Final Value Study Report

I-95/SR-9 from S. of Miami Gardens Drive to Broward County Line Miami-Dade County, Florida District 6

Financial Project ID: 414964-1-22-05
VE Contract No: CAP39
VE Task Work Order: #1
VE Study No. 2400601
Workshop Dates: November 13 to 17, 2023
Final Report Date: July 11, 2024

Deliverable: Value Engineering Study Report
Project: I-95/SR 9 from S. of Miami Gardens Drive to Broward County Line PD&E VE Study
Client: FDOT, District 6
Location: Miami-Dade County, Florida

Figure ST-2-2: PD&E Preferred Alt. Bridge Configuration at MGD and I-95 Intersection

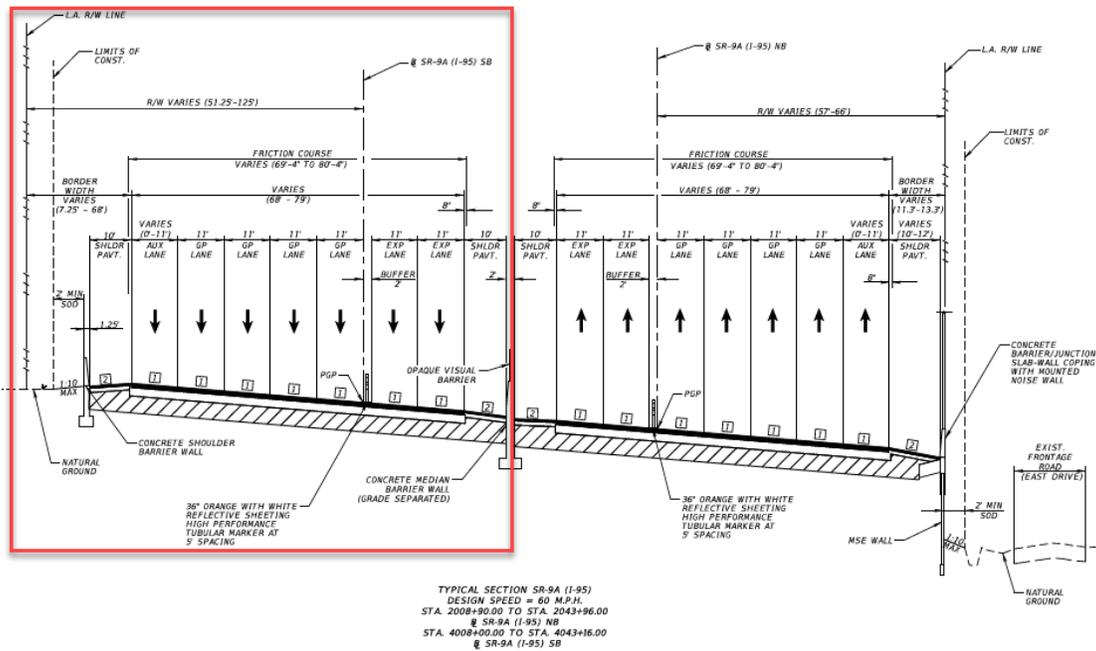
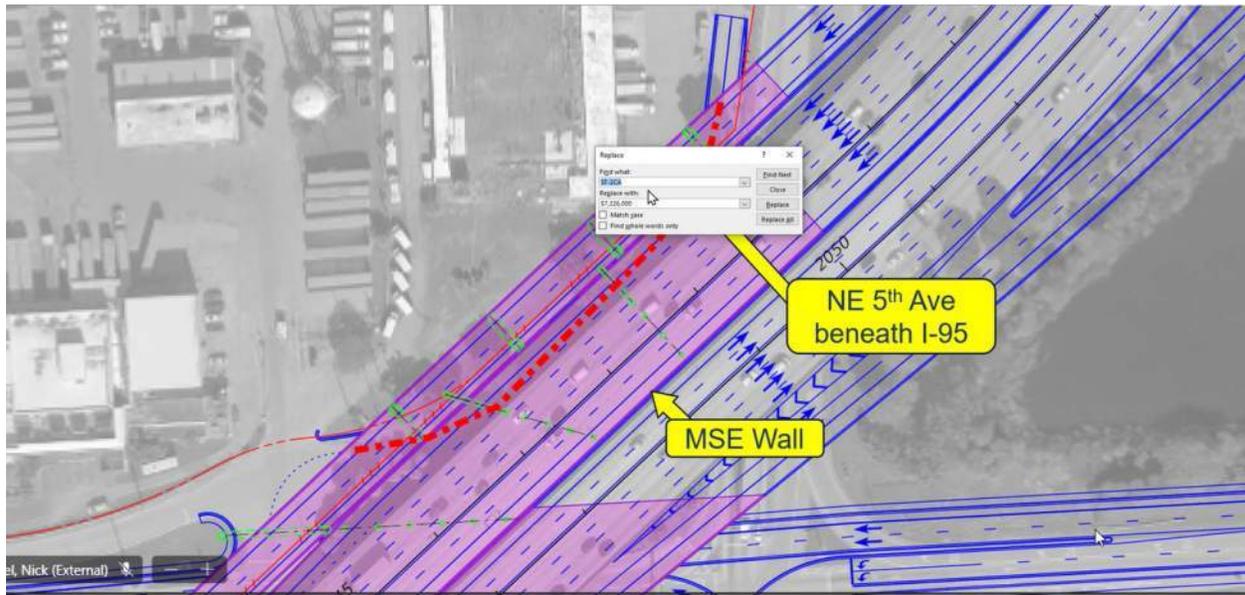
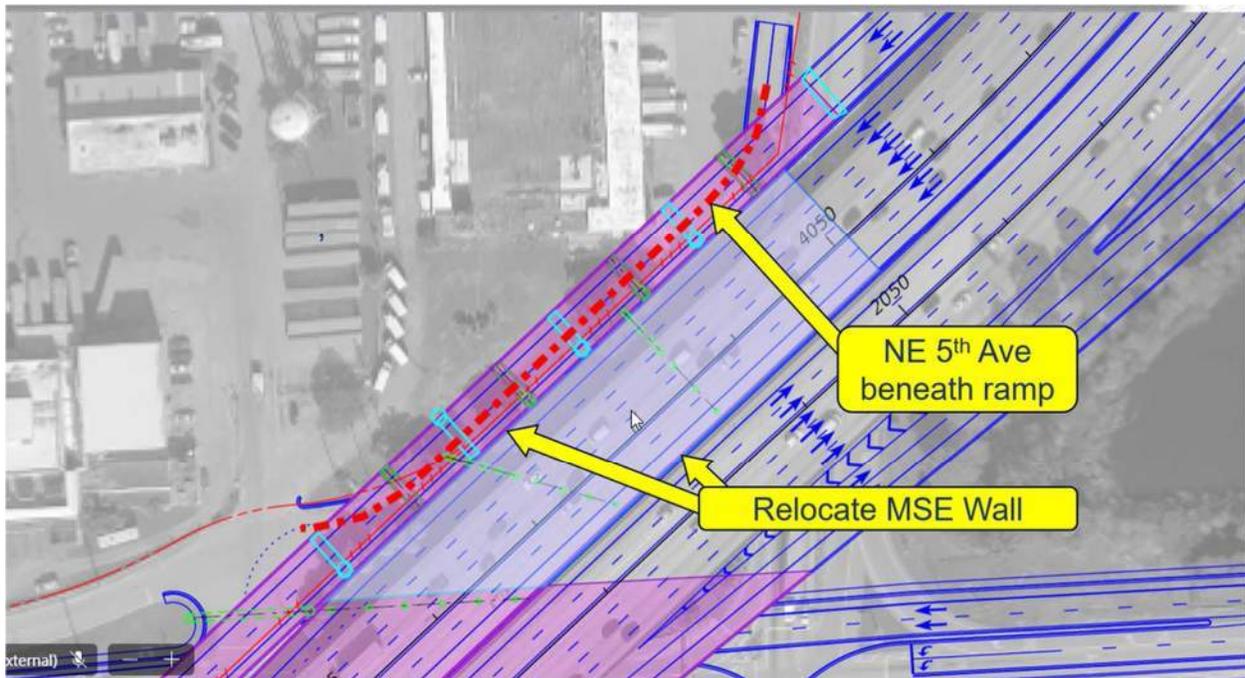
- This proposal does not add additional ROW acquisition, but requires close coordinate with nearby businesses (as would be needed for the PD&E preferred alternative).
- NE 5th Ave alignment would require curvature adjustments.

ST-2	Reconfigure NE 5th Ave beneath SB I-95 ramp to reduce SB I-95 bridge length crossing Miami Gardens Drive	-2	\$7,226,000	Reject	The PD&E team will not implement this proposal as it would result in R/W and access impacts to private property				X	
Traffic										
TR-1	Add signalized pedestrian crossing at NE 9th Court on Miami Gardens Drive	2	(\$131,000)	Reject	The PD&E team will not implement this proposal as a midblock signal is already being proposed west of NE 9th Court closer to Milton Littman Park	X				
TR-2	Extend Miami Gardens Drive south side sidewalk east to NE 10th Avenue and eliminate sidewalk on the north side between NE 2nd Court and NW 9th Court	2	\$11,000	Partially Accept	The PD&E team will extend the south MGD sidewalk to NE 10th Avenue; but will not eliminate the north MGD sidewalk between NE 2nd Court and NW 9th Court.	X

Figure TR-1-2: VE Team's Proposed Pedestrian Route Connection along Miami Gardens Drive

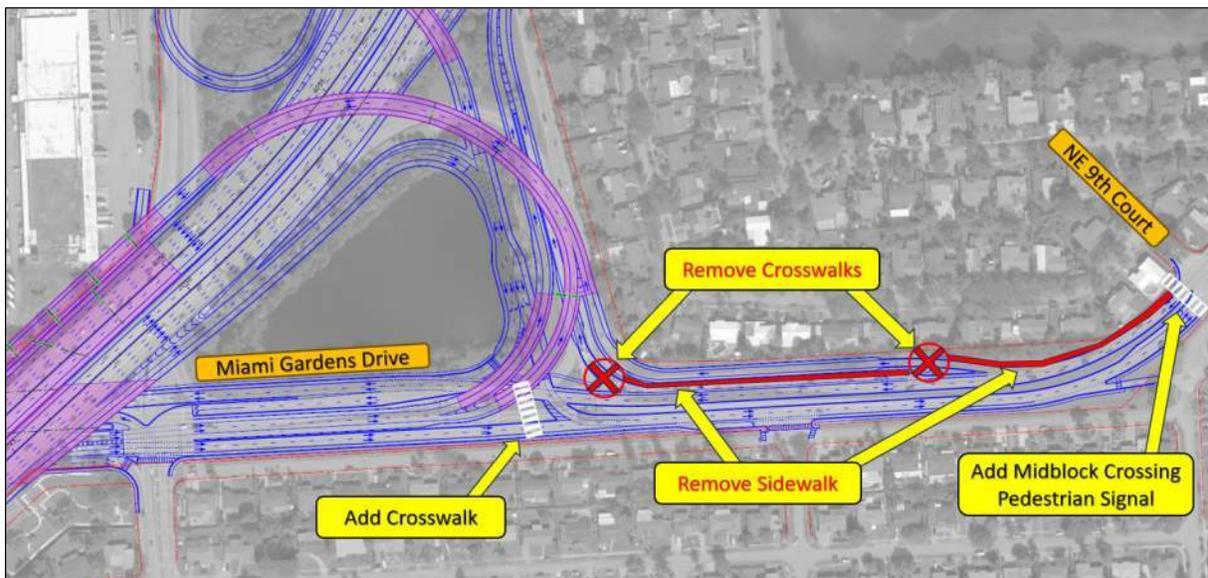
The VE team proposes to eliminate the sidewalk on the north side of MGD between 6th Ave and 9th Court and introducing a mid-block crossing pedestrian signal on MGD at NE 9th Court as shown in Figure TR-1-2. In response to concerns raised by the PD&E Team during the Mid-week Review Meeting, the VE Team acknowledges the recommendation to avoid a sidewalk crossing at 5th Ave due to the presence of "turbo lanes" at that location. Instead, a crosswalk at the eastbound ramp entrance onto I-95 with an existing signal is suggested to guide pedestrians from the south side of MGD to the north side.

- Improved safety for pedestrians, eliminating the need to cross I-95 entrance ramps to access the sidewalk.
- Enhanced mobility for drivers on entrance ramps, avoiding interruptions from crosswalks and potential pedestrian crossings on the ramp.
- The signal will provide westbound drivers with an opportunity to stop, read signs, and make informed decisions given the complex configuration of the ramps.
